ADDENDUM NO. 2

**CONTRACT DOCUMENTS
AND
TECHNICAL SPECIFICATIONS
FOR
HVAC UPGRADES
&
INTERIOR RENOVATIONS
&**

GREENWOOD LAKE PUBLIC LIBRARY

LAN Job #4.1361.05

2
P2.01
1/8" = 1'-0"

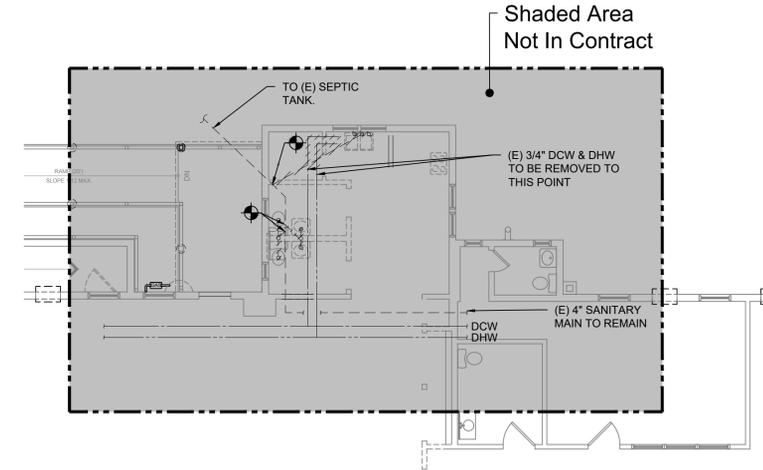
Drawing No.	Addendum Requirements
P2.01	Modified 2/P2.01 clarifying the scope of work and the add alternates.
P2.02	Modified GAS RISER DIAGRAM clarifying the scope of work and the add alternates.
